Response to Comments Document

# DAIRY MANURE DIGESTER AND CO-DIGESTER FACILITIES

Final Program Environmental Impact Report  
SCH No. 2010031085

Prepared for  
California Regional Water Quality  
Control Board, Central Valley Region

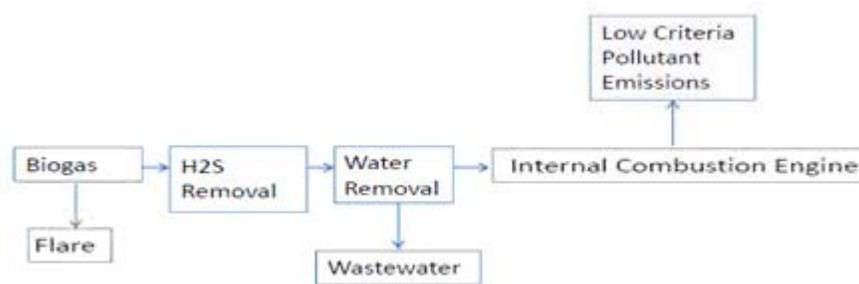
removal is included in the schematics for comparable energy capture technologies on the same page. This suggests incorrectly that such technologies are not used nor required in the Central Valley when the opposite is true. The schematic should be revised to include this information.

The schematic drawing for Alternative 1: Raw Combustion in Internal Combustion (IC) Engine or Flare on page 3-16 of the draft Program EIR has been revised to include removal of hydrogen sulfide and water from raw biogas before combustion in IC Engines. The drawing has also been revised to show cleanup of exhaust via catalytic treatment. This information is shown below:
